September 22, 2023

Re: Compiled City Comments for Concept 1 for PRGS Blocks A, B and C
CDSP#2022-00030 (Block A); CDSP#2022-00031 (Block B) and
CDSP#2022-00032 (Block C)

Exhibit 1 – PRGS Developer Contribution Condition

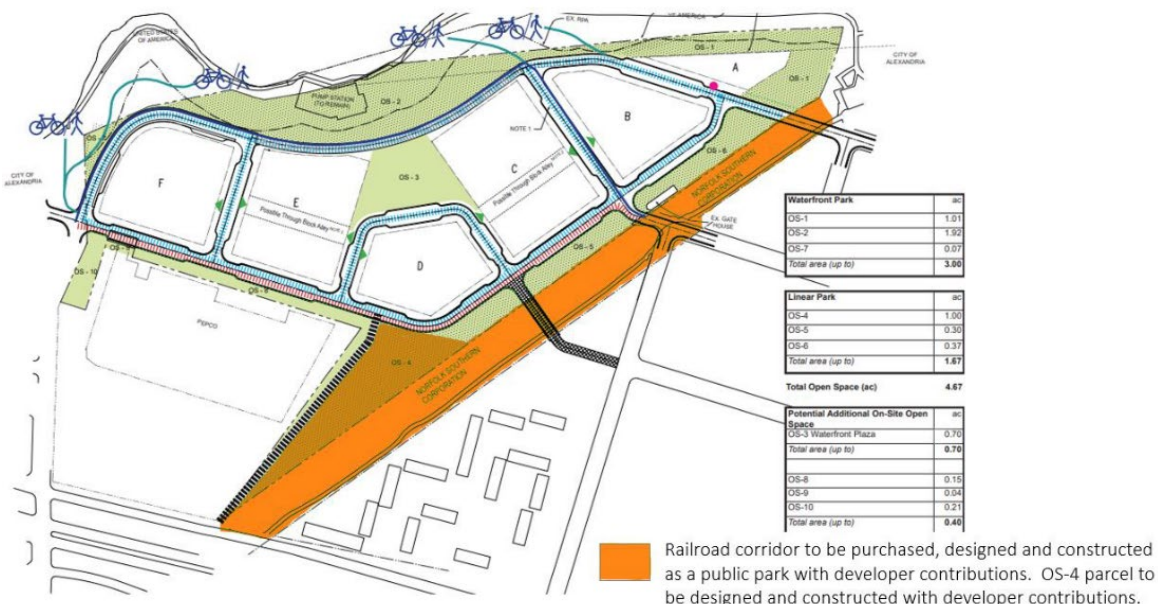
- b. The developer contributions shall be used for the following:
 - i. The Linear Park Norfolk Southern Railroad Corridor (Segment 2 in OTN Plan) and OS-4 as generally depicted in Exhibit 1.

- ii. Waterfront Park As generally depicted in the CDD Concept Plan submission as parcels OS-1, OS-2, and OS-7, as well as improvements made to the adjacent Waterfront Park land controlled by National Park Service (NPS), if approved by the National Park Service (NPS). Improvements to the Pumphouse not related to open space improvements will not count towards the contribution.

Response: It is anticipated that this condition will be wholly fulfilled through the significant in-kind improvements the project is delivering both on- and off-site. Calculations for in-kind contributions related to the improvements to the Waterfront Open Space (OS-1, OS-2, OS-3), Waterfront Park (on NPS property, with NPS coordination and approval), the Linear Open Space (OS-4, OS-5, OS-6, OS-8, OS-9, OS-10), the Railroad Corridor Park (currently owned by Norfolk Southern) will be provided in accordance with the timeframe contemplated in the CDD Condition. Applicant will estimate what portion of the contribution is attributable to each block, however, the in lieu of calculation is based upon the scope shown in the Open Space DSUP approval and determined prior to release of the final site plan for each open space.

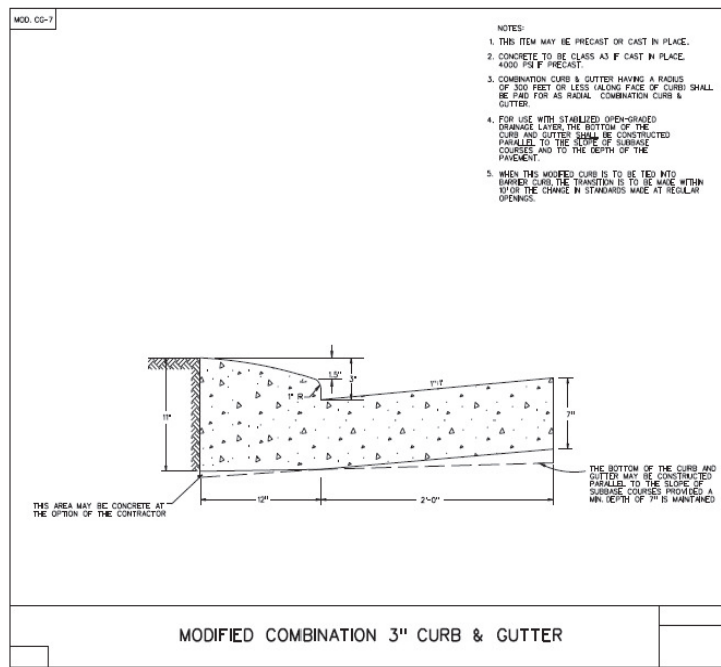
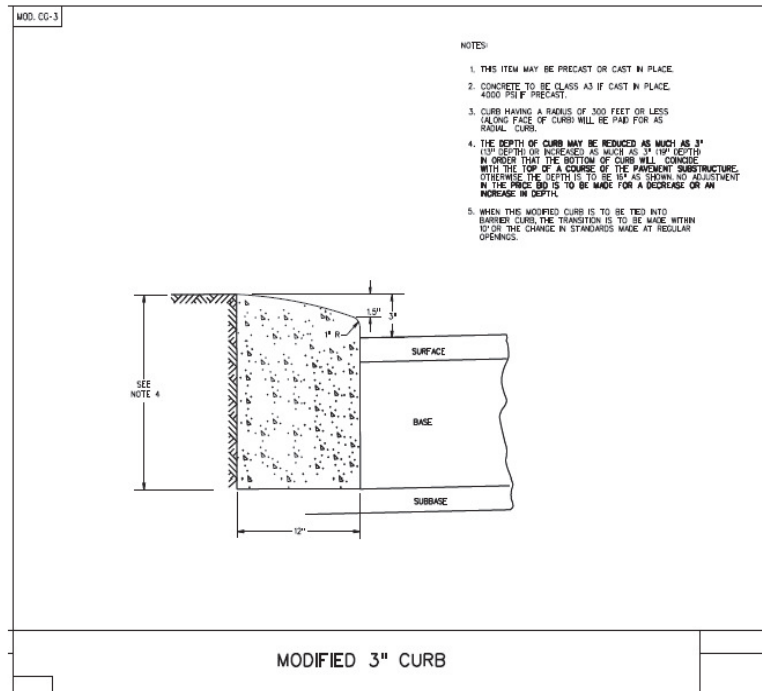
11. The fire service plan shall show placement of emergency vehicle easement signs. See sign detail and placement requirements are as follows:
 - a. Emergency vehicle easements shall be a minimum of 22 feet across the travel lane. The emergency vehicle easement shall provide access to strategic areas of the building and fire protection systems. Curbing and street components shall conform to the standards established by Transportation and Environmental Services and this document for emergency vehicle easements.

by 6 inches solid shaft with solid head - 1½ inches wide and 2 inches deep (For examples, see Figures D102.1, D102.2, and D102.3). Signs shall be mounted with the bottom of the sign 7 feet above the roadway and shall be properly attached to a signpost or other approved structure such as designated by the fire official. Posts for signs, when required, shall be metal and securely mounted. Signs shall be parallel to the direction of vehicle travel and posted so the directional arrows clearly show the boundaries and limits of the Emergency Vehicle Easement. In areas where emergency vehicle easements involve two-way traffic, double mounted signs shall be provided. The maximum distance between signs shall be 100 feet. Other special signs or modifications to emergency vehicle easement signs shall be approved by the fire official.

- c. Where curbing is a component of the emergency vehicle easement, the curbing construction shall conform to weight and grade requirements for vehicular traffic. In no circumstances shall a raised curb be in the path of travel in an emergency vehicle easement. Where a mountable curb is provided as part of an emergency vehicle easement, emergency vehicle easement signs shall be posted at the point nearest the edge of the emergency vehicle easement, but in no case within the clear width of the emergency vehicle easement. Except for flush curbs, any fire department access points that require fire apparatus to mount a curb shall conform to the modified 3-inch curb design standard MOD CG-3 or MOD CG-7 design as shown.

Response: Acknowledged.

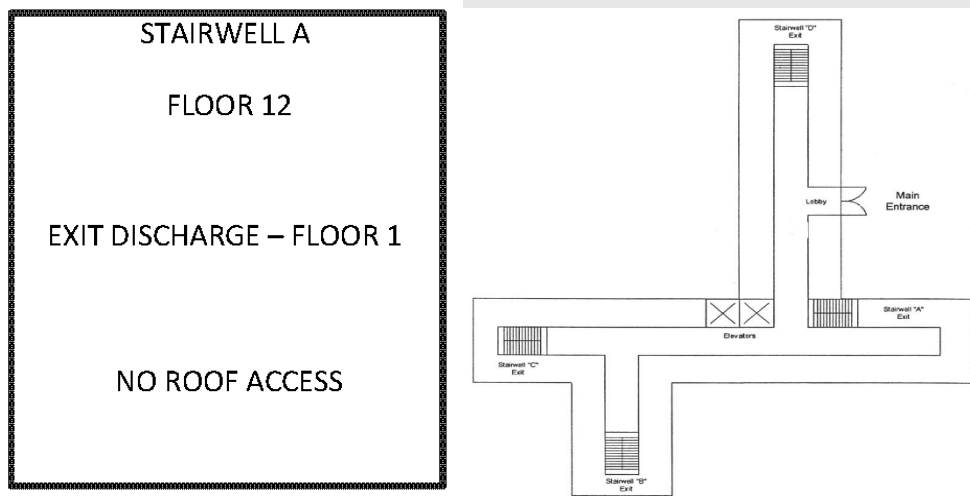
12. Show fire apparatus vehicle turning radius based on the following specifications:
- a. Turning Radius – Wall to Wall = 44 feet 6 inches
 - b. Curb to Curb = 36 feet 5 inches
 - c. Inside turning radius = 20 feet 3 inches
 - d. Overall Length – 46 feet 9.25 inches
 - e. Overall Width – 101 inches
 - f. Wheelbase from front axle to both rear axles – 257 inches
 - g. Tandem axle spacing – 55" CL of axle to CL of axle
 - h. Gross Weight – 80,000 pounds as built with no equipment or water gross weight
 - i. Angle of Approach – 9 feet 7 inches
 - j. Angle of Departure – 10 feet 8 inches
 - k. Ramp Break Over – Break over angle is 4.42°

Response: Acknowledged.
